Application information	
Address	• 176 Baileys Mountain Road, Upper Coomera • 202 Baileys Mountain Road, Upper Coomera • 31 Courtney Drive, Upper Coomera • 41 Courtney Drive, Upper Coomera • 53 Courtney Drive, Upper Coomera • 288 Reserve Road, Upper Coomera • Lot 57 Reserve Road, Upper Coomera
Lot and plan & Site area	• Lot 183 RP156422 - 31,000m² • Lot 58 SP191940 - 30,870m² • Lot 184 RP173727 - 30,140m² • Lot 185 RP173727 - 30,170m² • Lot 186 RP173728 - 30,030m² • Lot 56 RP162858 - 30,580m² • Lot 57 SP214370 - 31,120m² • Total – 213,910m²
Type of development and proposed use	Reconfiguring a lot for a 7 into 195 lot subdivision, including: • 187 residential lots • 5 drainage lots • 2 open space lots (1ha park and recreation linkage) • 1 environmental lot • new public roads
Categories of development and assessment	Development permit (Impact assessment)
Properly made date	20 December 2024
Decision due date	4 February 2026

The purpose of this report is to assess an application for a Development permit for Reconfiguring a lot for a 7 into 195 lot subdivision (including 187 residential lots, 5 drainage lots, 2 open space lots, 1 conservation lot, and new public roads) at 176 & 202 Bai

Figure 20: Courtney Drive roundabout functional layout drawing (Source: OSKA Consulting)

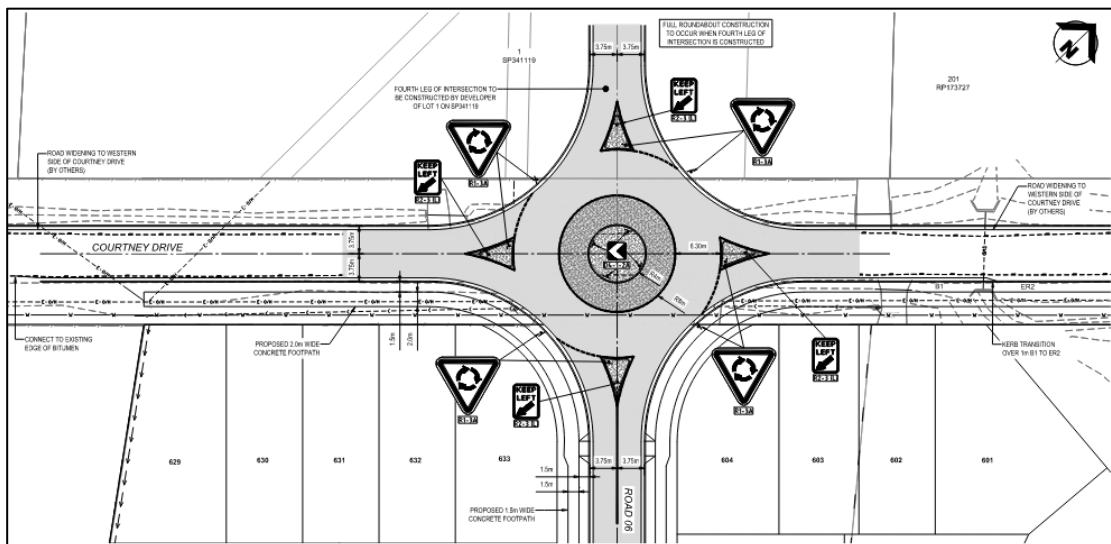
- The 'functional layout drawing' ('*External Roundabout Plan*') prepared by Oska Consulting Group shows that construction of the roundabout will rely (to some extent) on land that is not controlled by the applicant – the NW leg of the roundabout, in addition to the 'eastbound' circulating carriageway, will require land to be dedicated from lot 11 SP341124 (in order that the roundabout is wholly located within the public road reserve).

Transport Assessment has recommended the following changes (via amendments) to the 'functional layout drawing' for the Courtney Drive / Site Access roundabout:

Figure 21: Baileys Mountain Road functional layout drawing (Source: Colliers)

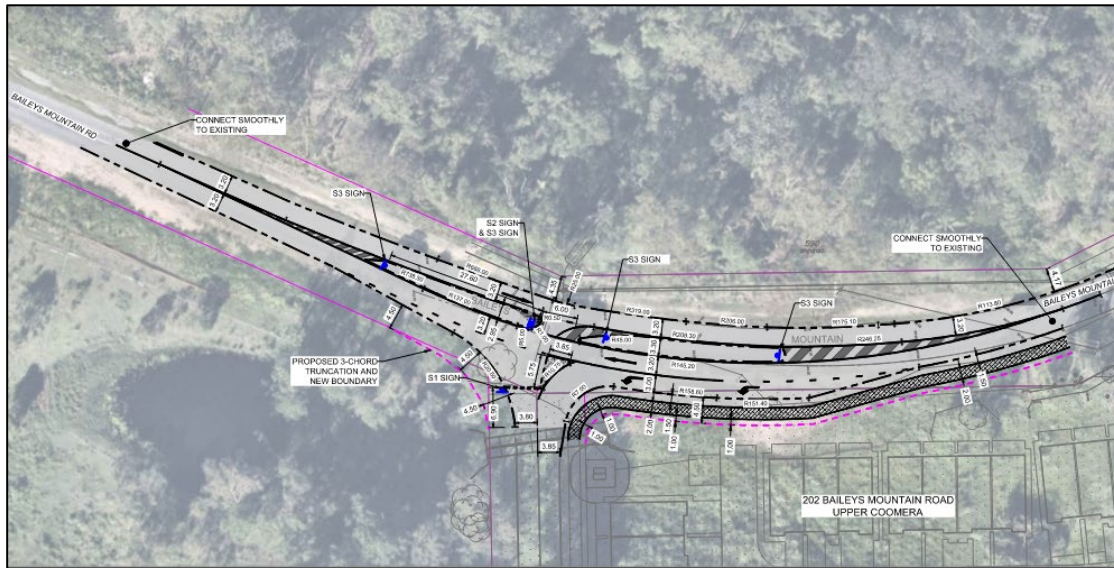
Colliers has prepared a 'functional layout drawing' for the Baileys Mountain Road / 'Road 1' intersection, with comments on the design provided below:

Transport Assessment has recommended the following changes (via amendments in red) to the 'functional layout drawing' for the Baileys Mountain Road / 'Road 1' intersection:

Figure 1: Bulk earthworks drawings (Source: OSKA)

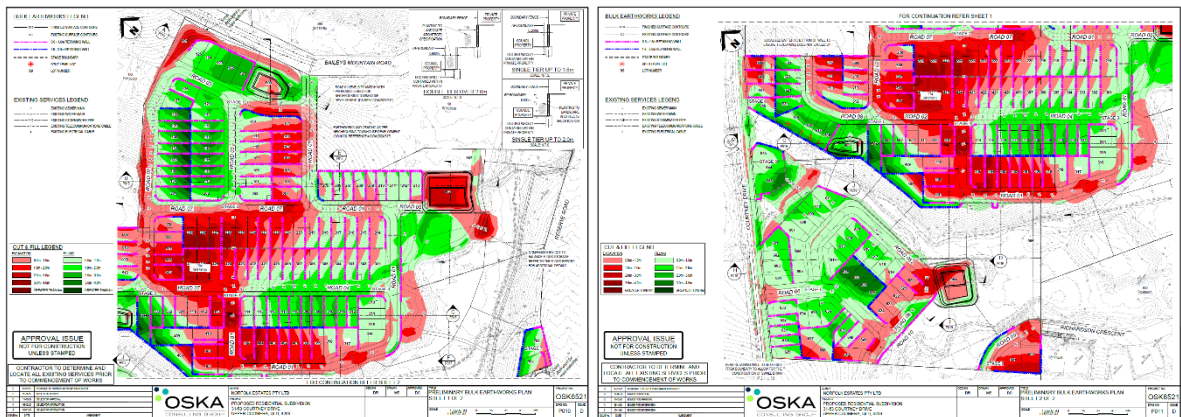
As retaining works and batters are nominated which do not achieve compliance with SC6.12 City Plan policy – Land development guidelines (LDGs), compliance with Acceptable outcome AO9 cannot be achieved. Accordingly, officers have considered the development against Performance outcome PO9.

The preliminary earthworks plans nominate single-tier retaining walls up to 2 metres in height and retaining walls between 2–3 metres as double-tiered. The proposal includes retaining works fronting new public road reserves, which are considered to negatively impact the future amenity of the area. The LDGs allow for retaining walls associated with residential activities up to 1.5 metres in height to a road verge interface. The applicant has nominated retaining works up to 1.6 metres in height along the boundary, with walls above 1.6 metres and up to 2 metres setback 600mm to allow for screening shrub landscaping, and walls above 2 metres and below 3 metres incorporating benching.

Officers consider allowances for a single-tiered wall to be acceptable at 2 metres instead of benching at 1.5 metres, provided screening shrub planting is incorporated. In addition, retaining works fronting a public road reserve are recommended to be constructed of concrete sleepers to minimise footing impacts to adjacent planting, and sleepers must be charcoal coloured with a textured finish (e.g. split-face or wood pattern etc.).
